**REQUEST**

Current Zoning: NC (neighborhood center)  
Proposed Zoning: MUDD-O (mixed use development, optional)

Approximately 0.94 acres located at the southeast intersection of Commonwealth Avenue and The Plaza, north of East Independence Boulevard.

## PLANNING STAFF REVIEW

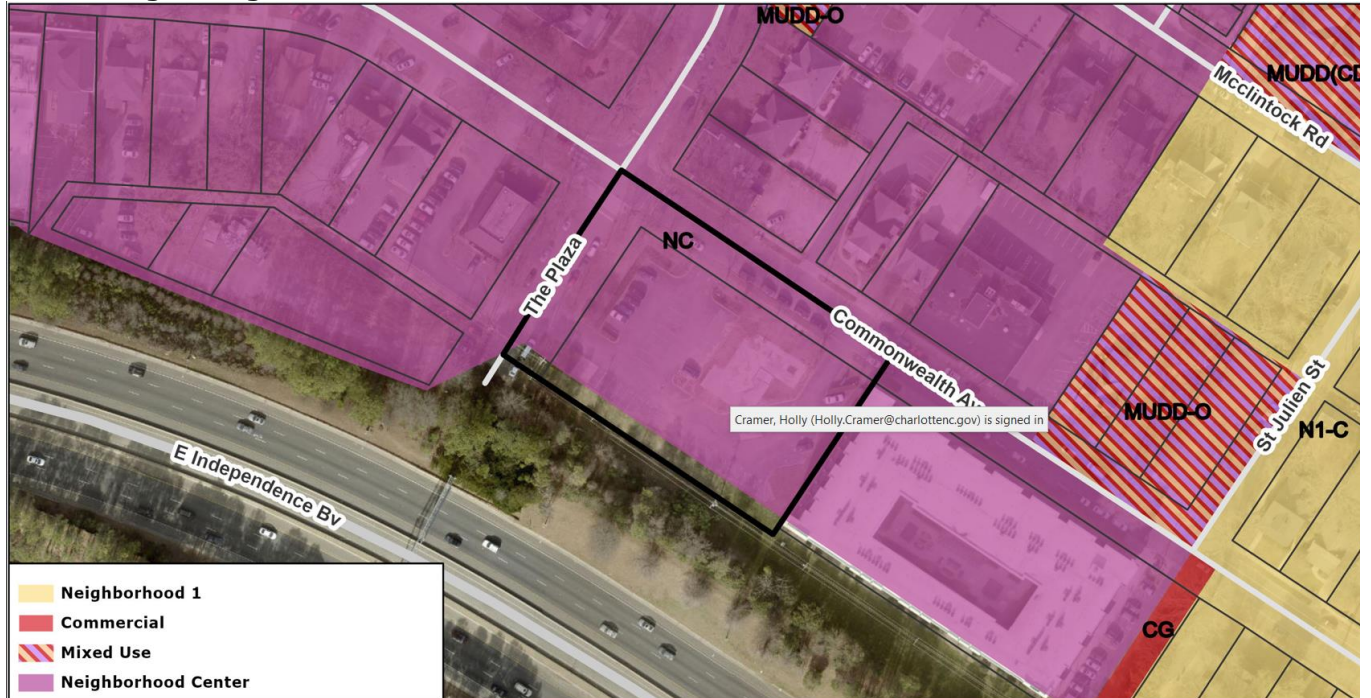
2. The back of curb sidewalk shown is not acceptable to CDOT, remove from plan. Based on the context of the street CDOT can consider a consider a local office/commercial wide with parallel parking and curb bumpouts per CLDSM U-05, with amenity zone instead of planting strip. In addition, remove proposed park — park not allowed in right-of-way. **Addressed**

4. Reduce the maximum height to provide contextual sensitivity to the surrounding building forms. **Addressed**

5. ~~Revise note 7 under the Design Guidelines to commit to community benefits to achieve building height above 80'. Commit to specific community benefits.~~ **Addressed**
  6. ~~Identify building envelopes(s) rather than one development area.~~ **Rescinded**
  7. ~~Remove optional provision allowing for a drive-through.~~ **Rescinded**
-
